Access Compliance Report

Public Rights-of-Way

Intersection ID: 30502	Main Street: ORCHARD_GRASS_CT	Cross Street: STONES_LANDING_ST	Location: SW
ADA ID: 3C930E77CCA7	Ramp Type: PerpDiag	Initial Pass/Fail: Fail	Overall Compliance: No
Severity Score: 35			
Codes/Mitigation Info/Possible Solution		Field Measurements/Component Compliance

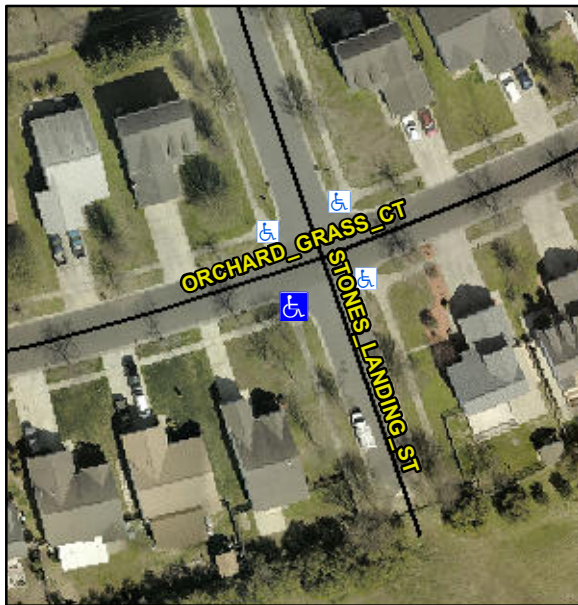
R304.5.1

Compliance	Description	Data	Compliance	Description	Data
N/A	Ramp Length (in)	56.0	Yes	Ramp Slope (%)	5.1
No	Ramp Width (in)	31.0	Yes	Ramp XSlope (%)	0.5
N/A	Flare Type LT	N/A	N/A	Flare Type RT	N/A
N/A	Flare Slope LT (%)	N/A	N/A	Flare Slope RT (%)	N/A
N/A	Flare Traversable LT?	N/A	N/A	Flare Traversable RT?	N/A
N/A	Landing Length (in)	N/A	N/A	DWS Provided?	N/A
N/A	Landing Width (in)	N/A	N/A	DWS Contrast?	N/A
N/A	Landing Slope (%)	N/A	N/A	DWS Length (in)	N/A
N/A	Landing X Slope (%)	N/A	N/A	DWS Full Width?	N/A
N/A	Landing Curb? (Y/N)	N/A	N/A	DWS Offset (in)	N/A
N/A	Shared Landing?	N/A			
N/A	Gutter Ponding?	N/A	N/A	Gutter Slope (%)	N/A
N/A	Gutter Lip Ht (in)	N/A	N/A	Gutter X Slope (%)	N/A
N/A	Painted X Walk1?	No	N/A	Painted X Walk2?	No
	X Walk 1 Direction	To E		X Walk 2 Direction	To N
N/A	X Walk 1 Width (in)	N/A	N/A	X Walk 2 Width (in)	N/A
	X Walk 1 Slope (%)	0.9		X Walk 2 Slope (%)	3.4
	X Walk 1 X Slope (%)	1.7		X Walk 2 X Slope (%)	0.5

Remove & Replace Curb Ramp With Two New Directional Ramps or Equivalent.
